Addendum No. 2
Page 1 of 6

TO: Prospective Respondents
SUBJECT: Addendum No. 2
PROJECT NAME: Renaissance Center Interior Renovations
JJC PROJECT NO.: B16008

ADDENDA TO THE PROJECT MANUAL:

SHEET NUMBER:
AD1.11

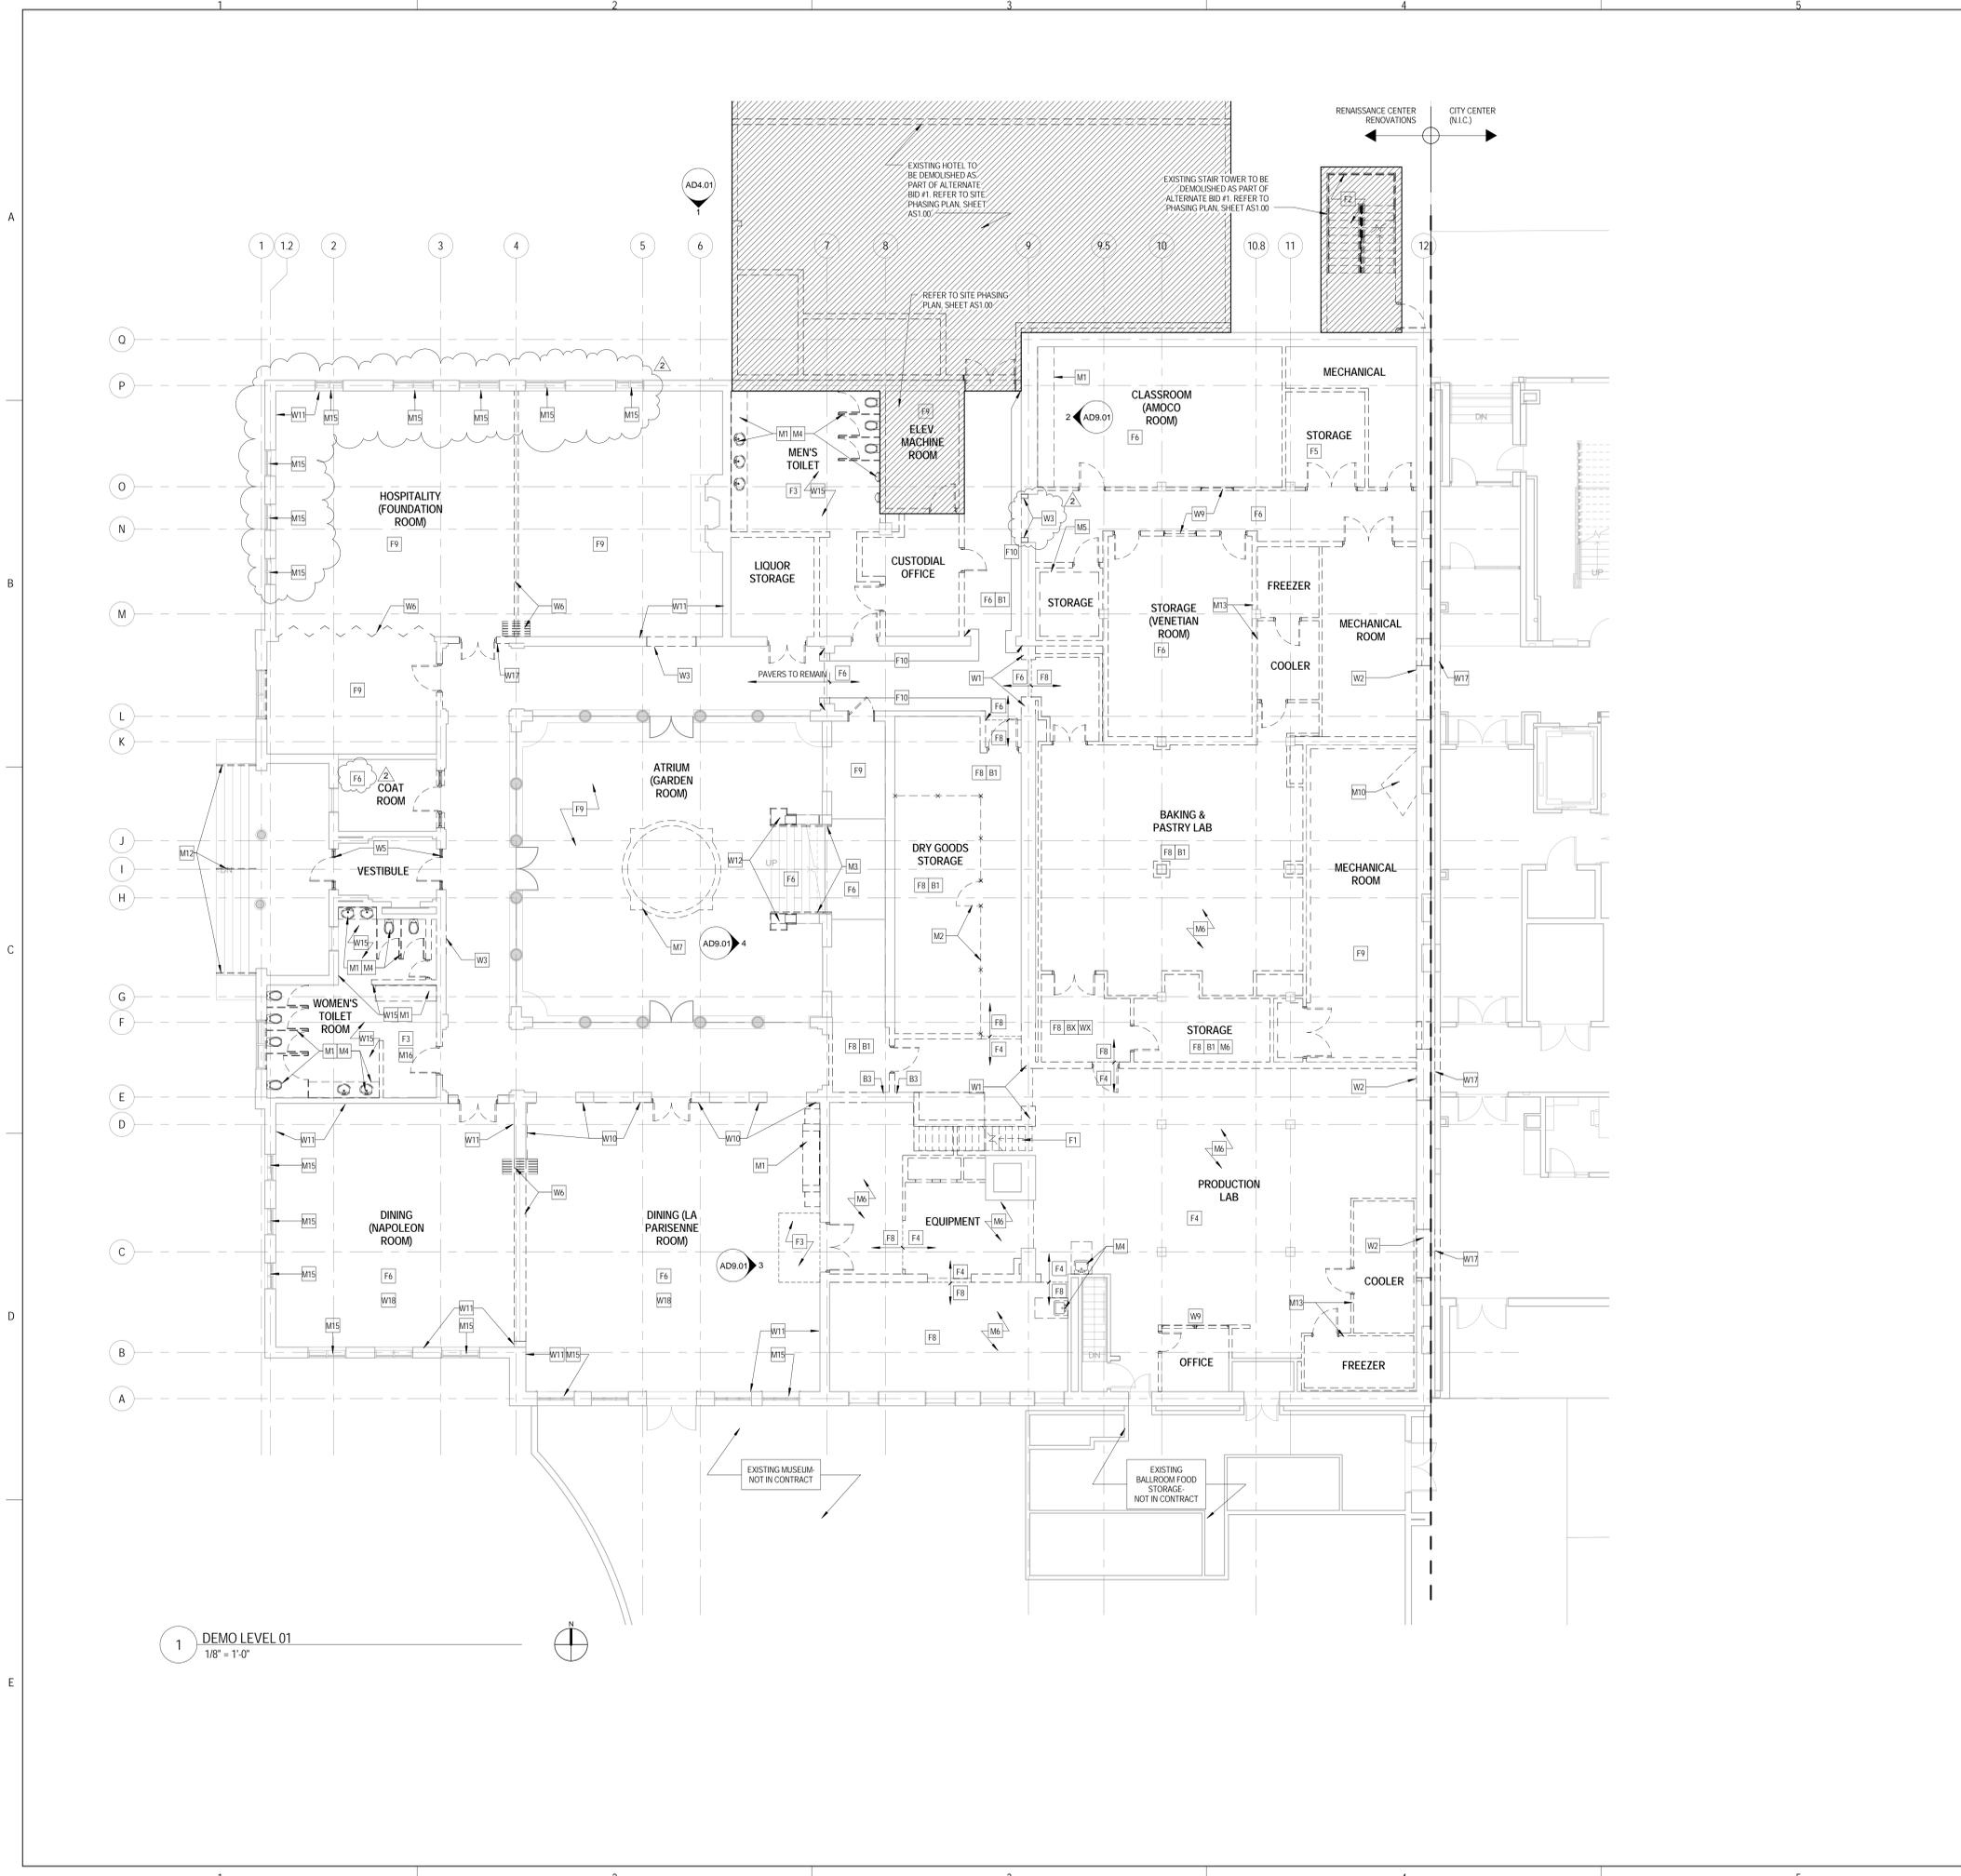
- E. All Demolition Sheets – Demo Floor Plan Referenced Notes: **REVISE** note W13 to read “REMOVE WALL OR PORTION OF WALL UNDER ALTERNATE BID #1. SHORE AND SUPPORT WALL STRUCTURE AND SECOND FLOOR STRUCTURE AS NECESSARY.”
- F. Sheet A1.21: **REVISE** detail 1 per attached **sketch A121-01**.
- G. Sheet A6.02: **REVISE** detail 1 note to read “REUSE EXISTING BLOCKING OR PROVIDE NEW BLOCKING AS REQUIRED.”
- H. Sheet A7.52: **REVISE** detail 10 note to read “REUSE EXISTING BLOCKING OR PROVIDE NEW BLOCKING AS REQUIRED.”
- I. Sheet A8.91: **REVISE** detail 5 note to read “6” COLD-FORMED STUDS TO ANCHOR OPERABLE PARTITION TO EXISTING STRUCTURE ABOVE.”
- J. Sheet A10.00: **REVISE** detail 2 per attached **sketch A1000-01**.
- K. Sheet A11.11: **REVISE** detail 1 per attached **sketch A1111-01**.

- W12: REMOVE PORTION OF EXISTING MASONRY WALL AS SHOWN. EXACT LOCATION TO BE DETERMINED BASED ON LOCATION OF EXISTING VISIBLE PLASTER LINE.
- W13: REMOVE WALL OR PORTION OF WALL UNDER ALTERNATE BID #1. SHORE AND SUPPORT WALL STRUCTURE AND SECOND FLOOR STRUCTURE AS NECESSARY.

PROJECT: 14-025
 DATE: 02.26.16
 REF SHEET: AD1.21

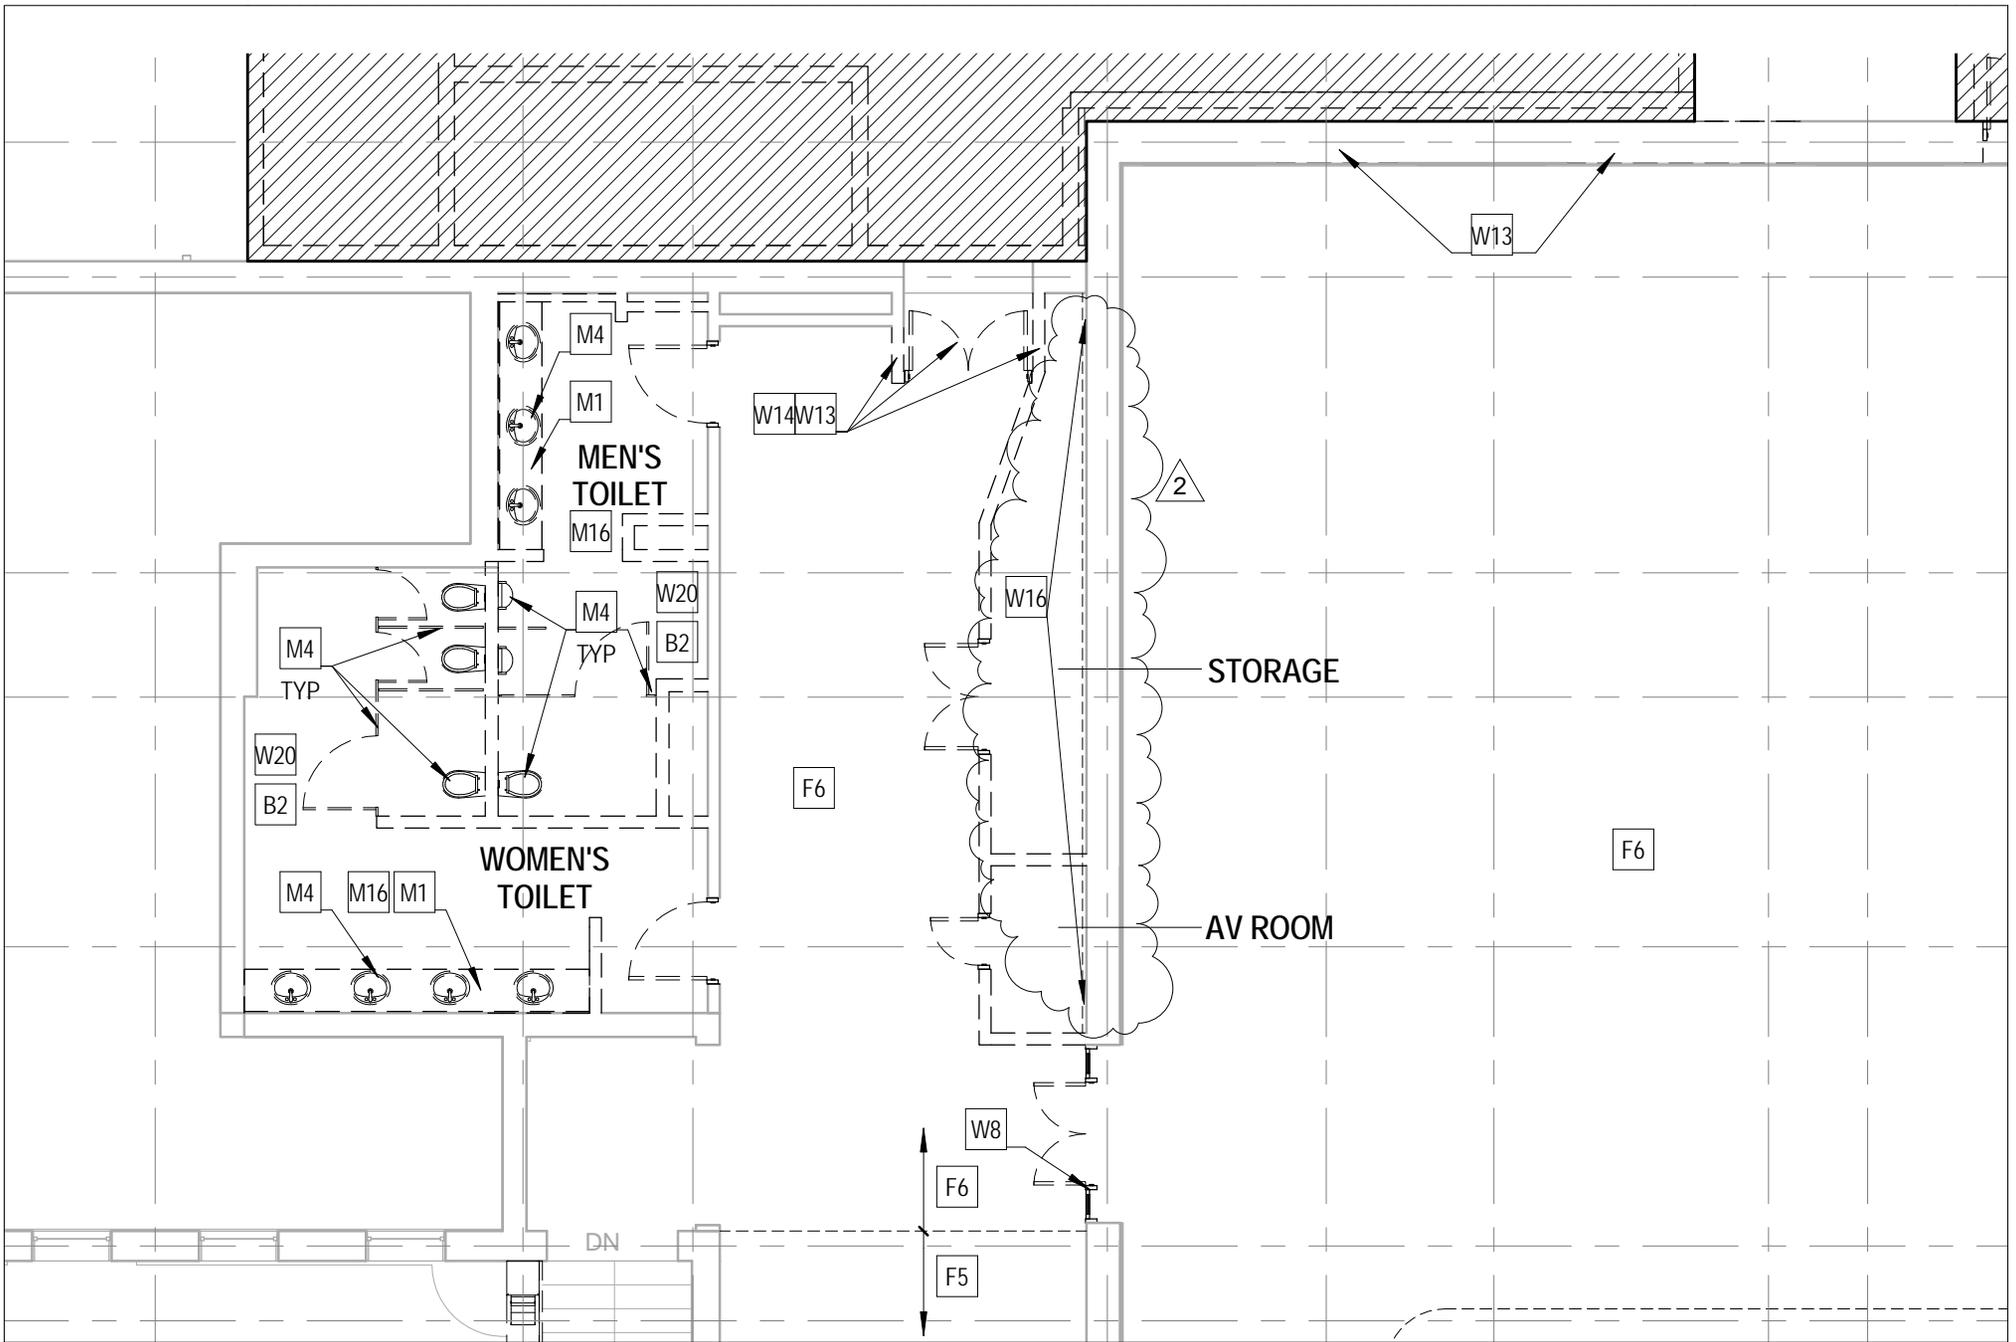
1. **Architectural Drawings**
 - A. **AD1.11, AD2.11, AD9.01, A9.01, A9.02, A9.03, A11.21: REPLACE** sheets in their entirety with those attached.
 - B. Sheet AD1.21: **REVISE** detail 1 per attached **sketch AD121-01.**
 - C. Sheet AD2.21: **REVISE** detail 1 per attached **sketch AD221-01.**
 - D. Sheet AD4.01: **REVISE** detail 1 note to read “EXISTING SCUPPER TO REMAIN. EXISTING DOWNSPOUT TO BE REMOVED AND REPLACED – SEE NEW WORK ELEVATION AND CIVIL DRAWINGS.”

M2.10

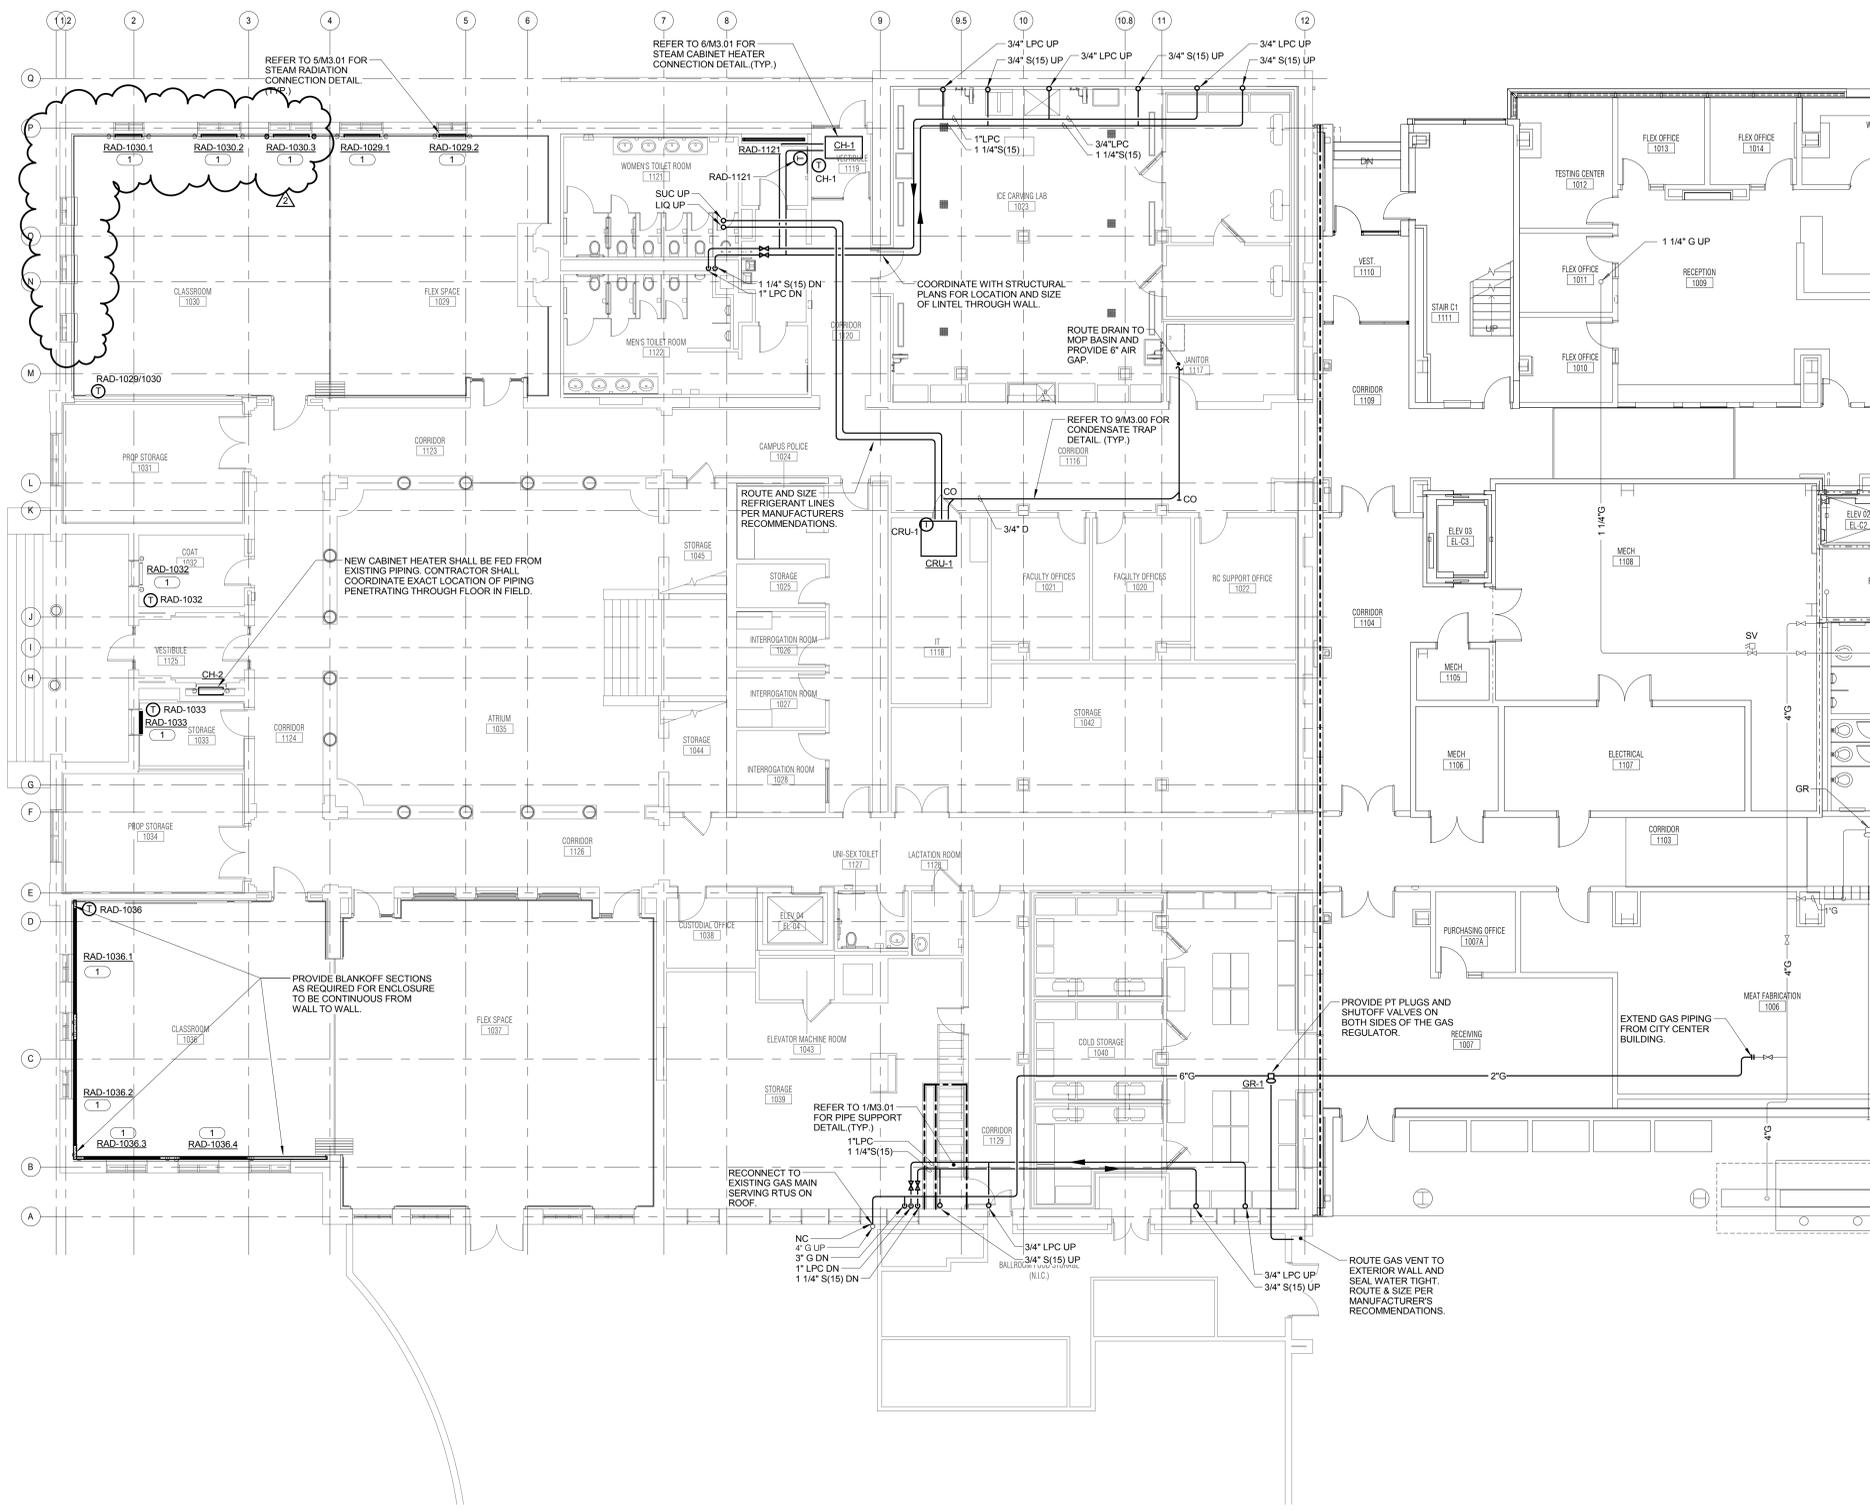
- A. Sheet MD1.00: **ADD** note “DISCONNECT AND REMOVE SECTION OF STEAM AND CONDENSATE PIPING FOR NEW BRANCH CONNECTION.” for new RAD-1030.3 on north wall of Room 1030.
- B. Sheets MD1.10: **REMOVE** three radiators located on west wall and one radiator in middle on north wall of HOSPITALITY (FOUNDATION ROOM).
- C. Sheet M2.00: **ADD** new 1-1/4” steam and 3/4” low pressure condensate piping to RAD-1030.3 in Room 1030.
- D. Sheet M2.10: **REMOVE** radiator on west wall. **MODIFY** tags for radiators located in CLASSROOM 1030. Refer to M2.10 for additional information.
- E. Sheet M5.00: Condensing Unit Schedule: **MODIFY** electrical information for CU-1. Radiation Schedule: **MODIFY** RAD-1030.1, RAD-1030.2 & RAD-1030.3. **REMOVE** RAD-1030.4, RAD-1030.5 & RAD-1030.6. Grilles, Registers & Diffusers: **MODIFY** RG-2. Refer to M5.00 for additional information.
